Proposal Request

PROJECT: *(name and address)*
AWSOM
Bentonville, Arkansas

PROPOSAL REQUEST 084

TBLH AV Revisions

1 | 2400/2410 TEAM BASED LEARNING HALLS
1/4" = 1'-0"

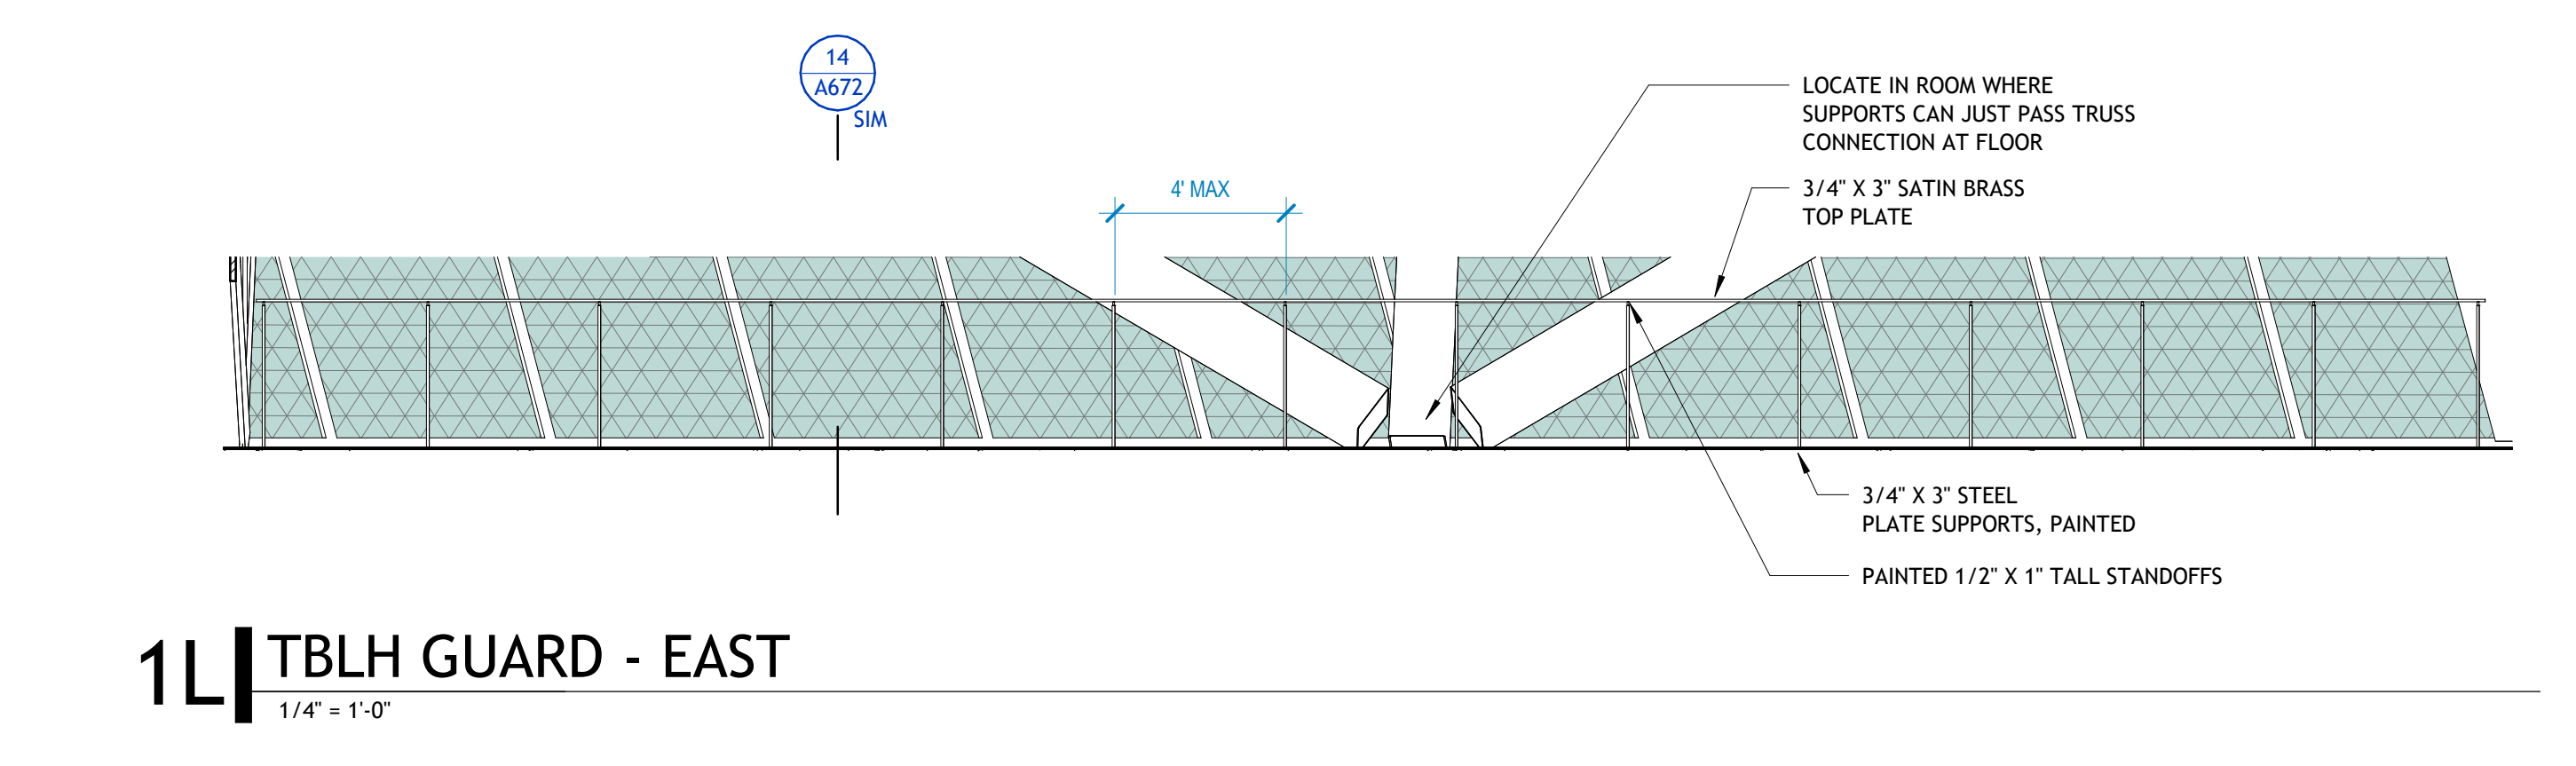
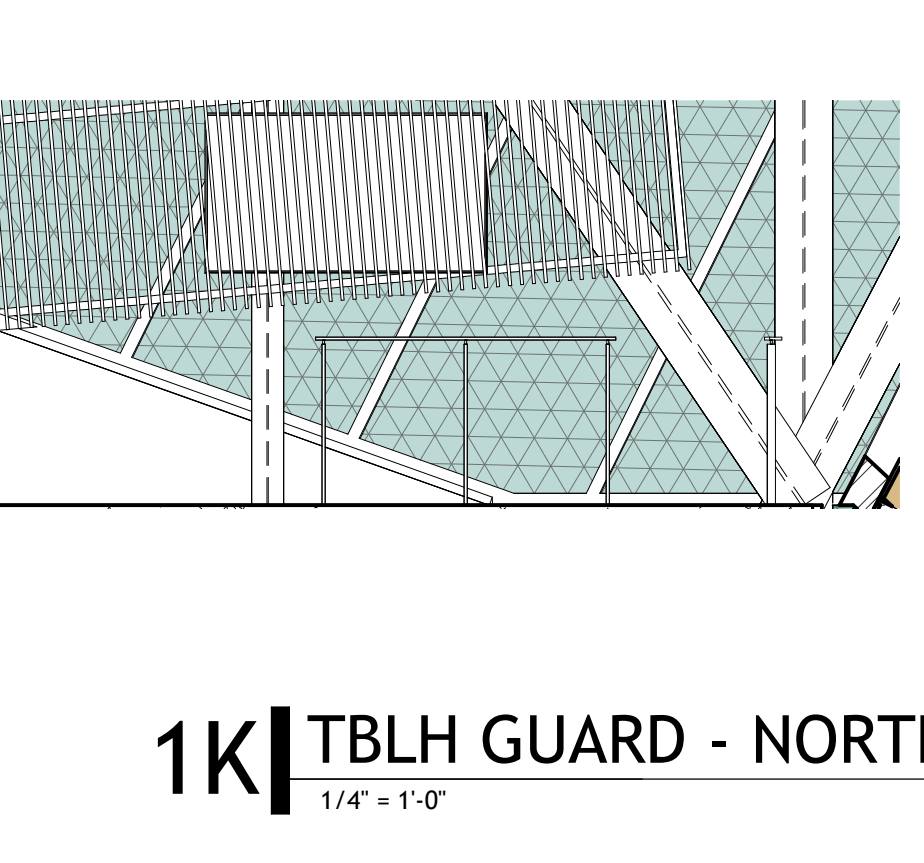
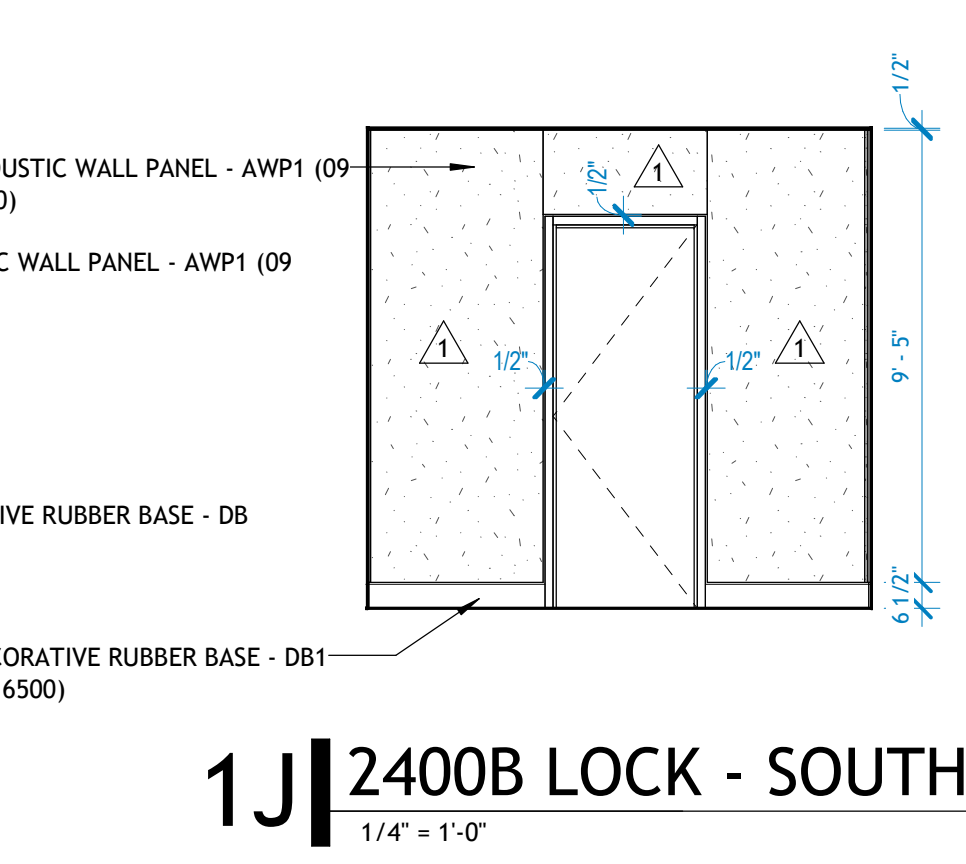
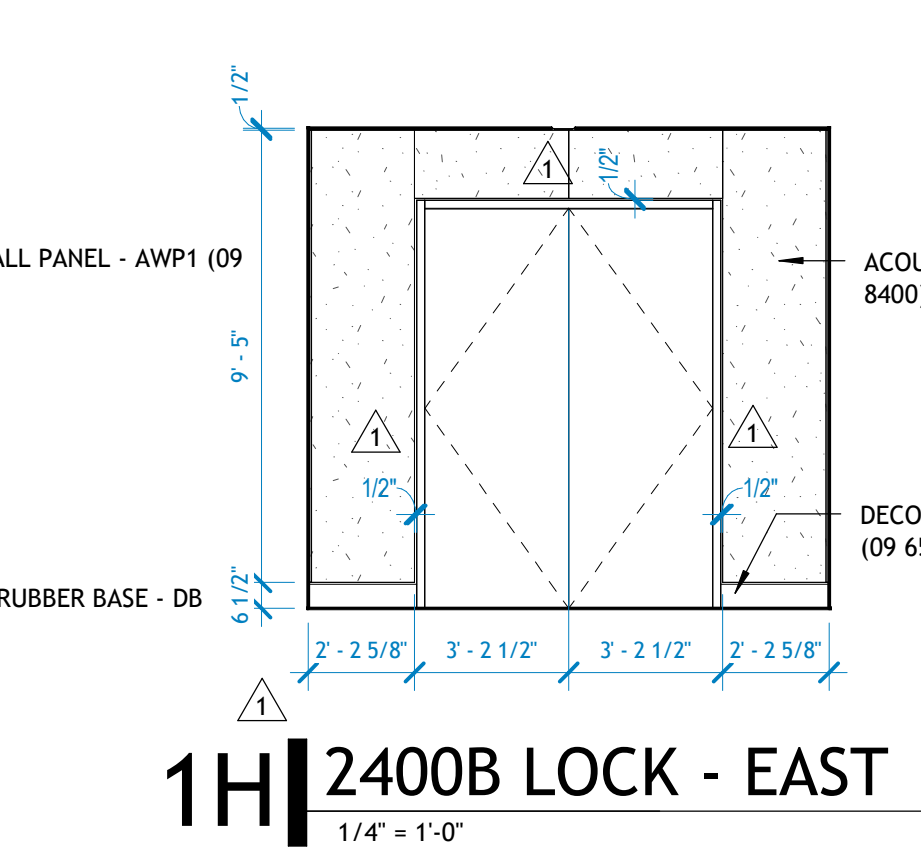
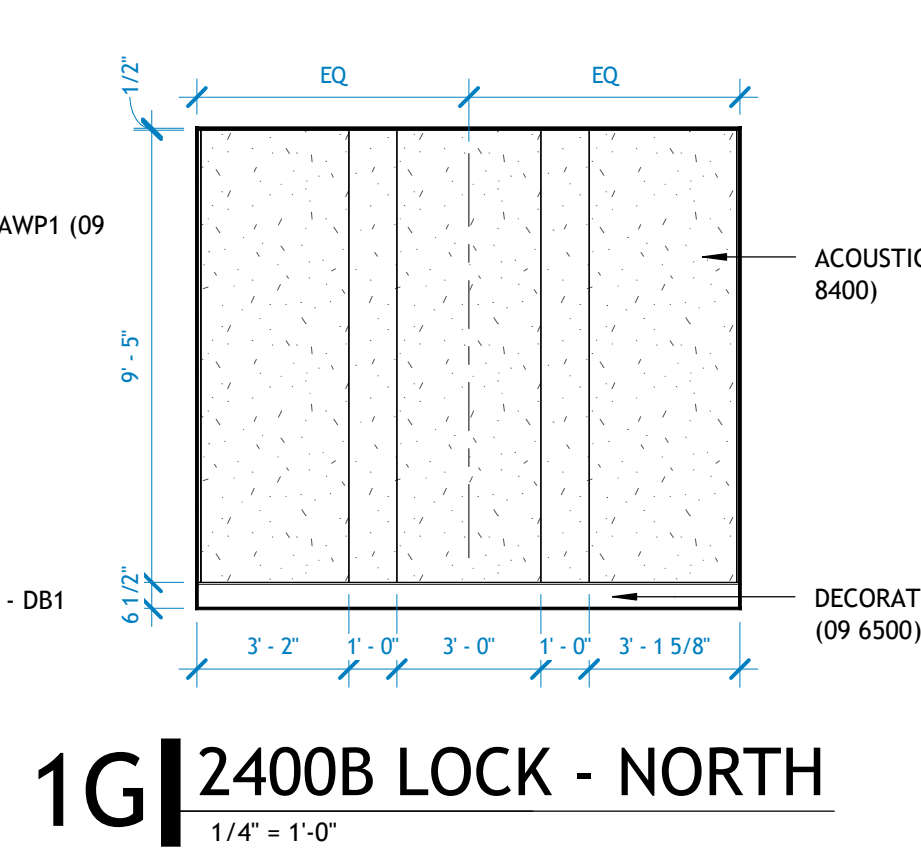
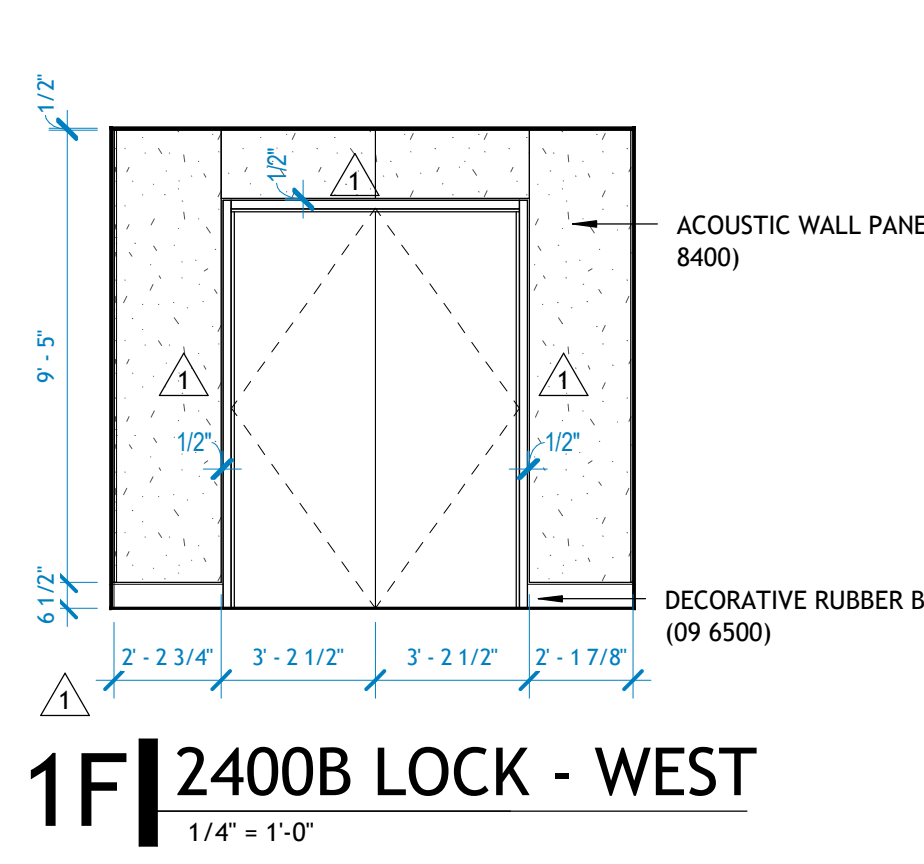
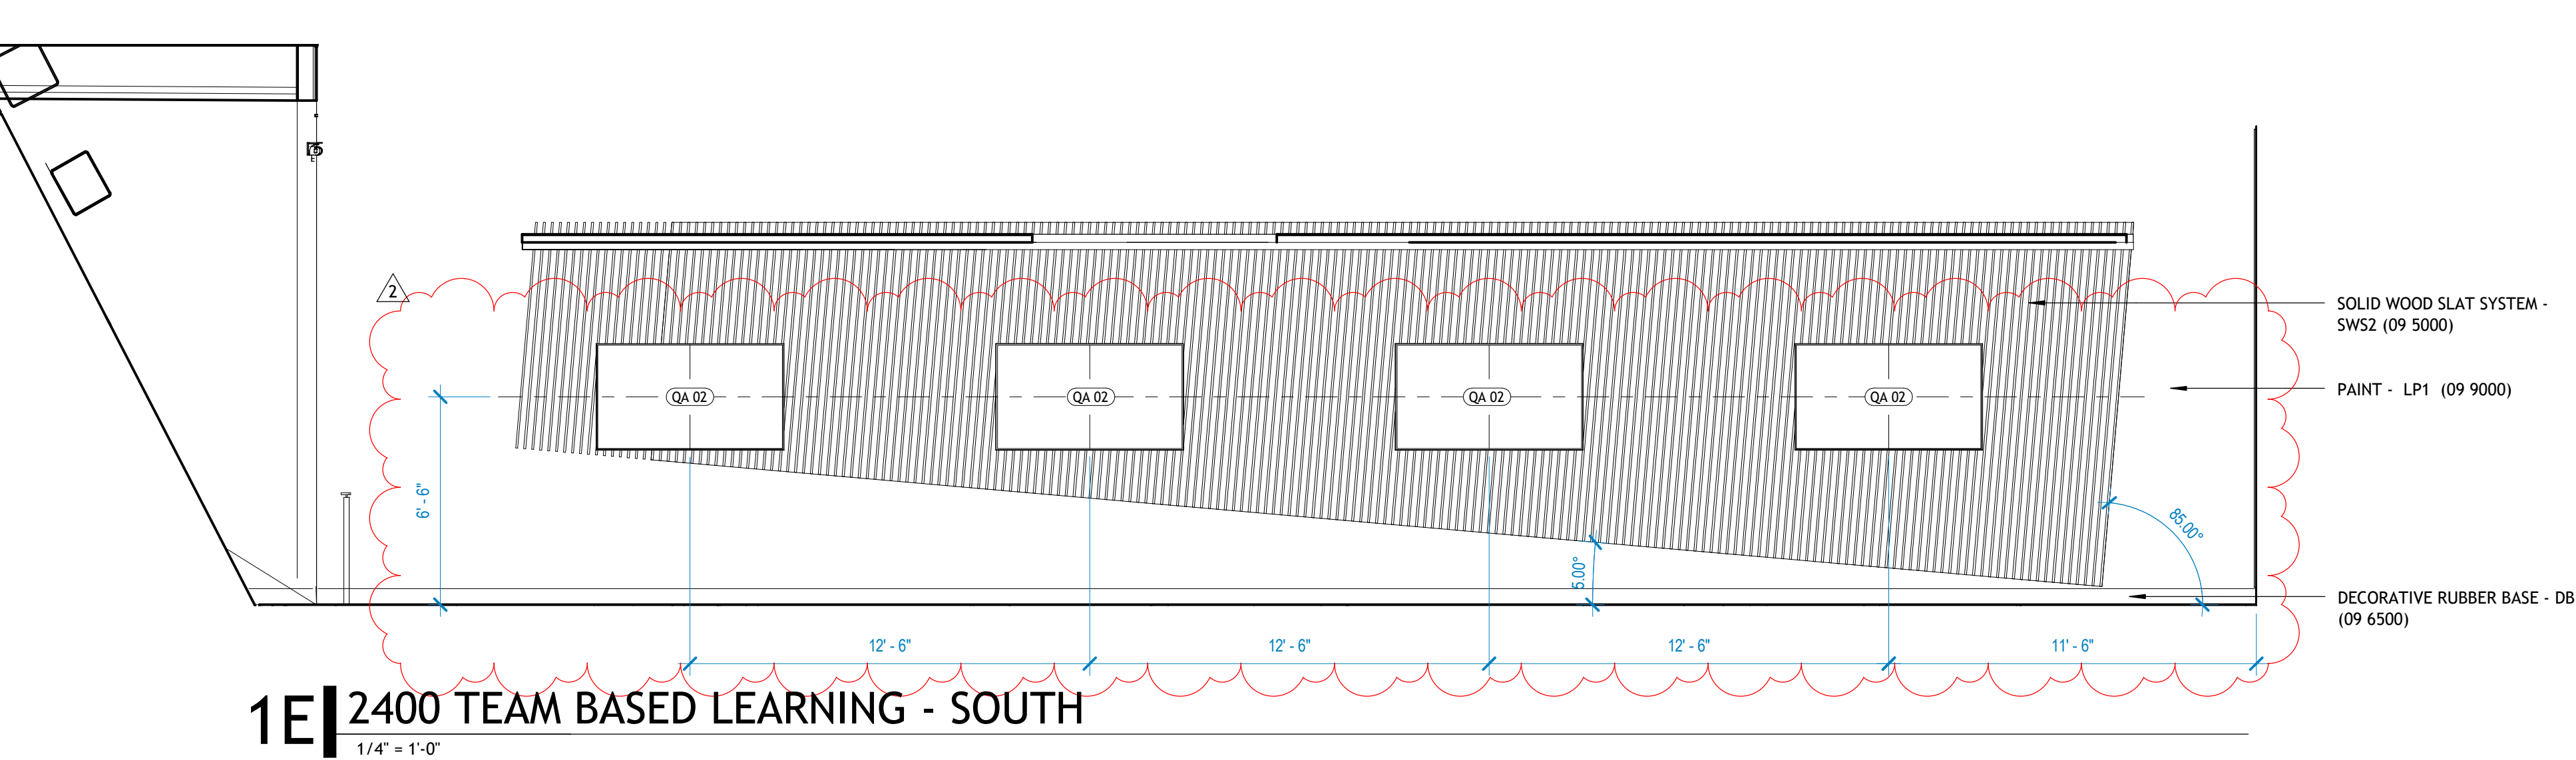
- a) Refer to Revised Sheet **A622**, with original issue date 02.24.2023 and revised date 09.25.2024.
 - Details 1, 1B, and 1E revised to show updated layout and amounts of TVs.
- b) Refer to Revised Sheet **A623**, with original issue date 02.24.2023 and revised date 09.25.2024.
 - Details 1, 2, and 3 revised to show updated layout and amounts of TVs.
- c) Refer to Revised Sheet **A912A**, with original issue date 02.24.2023 and revised date 09.25.2024.
 - Details 1, revised to show updated layout and amounts of TVs.
